**Committee of Experts on the Transport of Dangerous Goods  
and on the Globally Harmonized System of Classification  
and Labelling of Chemicals**

**Miscellaneous proposals for amendments to the Model Regulations  
on the Transport of Dangerous Goods: portable tanks**

**Report of the Informal working group on fibre reinforced  
plastics service equipment for portable tanks**

#### **6.9.3 Requirements for design, construction, inspection and testing of FRP service equipment for portables tanks**

Figure 42.3.1: Fire resistance test scheme

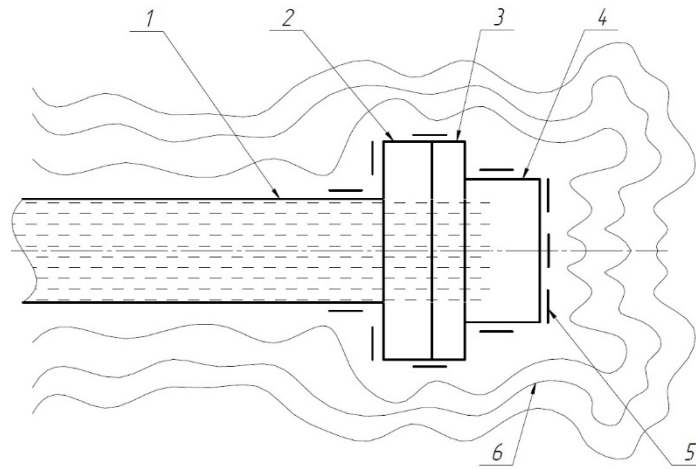
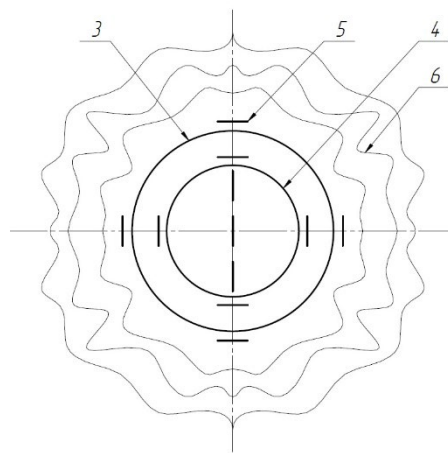
42.3.1 The fire resistance test is carried out for the test specimen installed in a closed position, filled with water with initial temperature of  $20 \pm 5^\circ\text{C}$ , under a pressure of 60 kPa at the equipment sealing surface, and exposures to flame for at least 30 minutes. The test specimen must be completely engulfed in the flame including the gate and seal assemblies. The general test scheme is given in figure 42.3.1. If the test specimen is an part of equipment which is not intended to be the outermost closure in a multi-closure system (such as a valve), then the test specimen may be equipped with a blind flange, at its outermost interface which would otherwise be exposed to flame during the test.

42.3.4 After the fire exposure and cooling the test specimen is subjected to a hydraulic leakproofness test under internal pressure 60 kPa. ~~to check the strength of the body, operation of the "open-closed" cycle (if any) and leakproofness test before and after operation of the "open-closed" cycle.~~
